Title of Change:	Improve FAB process variation of SuperFET3 FRFET by optimizing Mask design
Proposed First Ship date:	31 Aug 2023 or earlier if approved by customer
Contact Information:	Contact your local onsemi Sales Office or Yuna.Im@onsemi.com
PCN Samples Contact:	Contact your local onsemi Sales Office. Sample requests are to be submitted no later than 30 days from the date of first notification, Initial PCN or Final PCN, for this change. Samples delivery timing will be subject to request date, sample quantity and special customer packing/label requirements.
Additional Reliability Data:	Contact your local onsemi Sales Office or songyong.sim@onsemi.com
Type of Notification:	This is a Final Product/Process Change Notification (FPCN) sent to customers. FPCNs are issued 90 days prior to implementation of the change. onsemi will consider this change accepted, unless an inquiry is made in writing within 30 days of delivery of this notice. To do so, contact PCN.Support@onsemi.com

Final Product/Process Change Notification

Document #:FPCN24945XB

Issue Date:17 May 2023

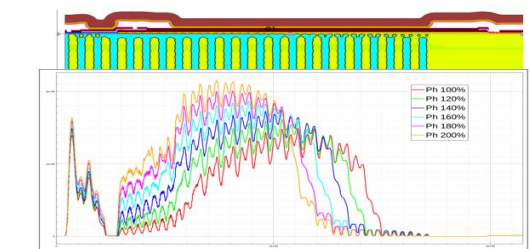
SF3 FRFET has a variation at BV_{dss} due to unstable charge balance, onsemi optimized PIL cell pitch and removed Si CNT ring in order to make stable charge balance margin and higher BV typical value.
Please refer below illustration.

Si contacted FP metal

BV_{dss} @ 250uA

❖ BV_{dss} drop @ P-rich status

❖ E-field stable distribution w/o Si contacted FP metal
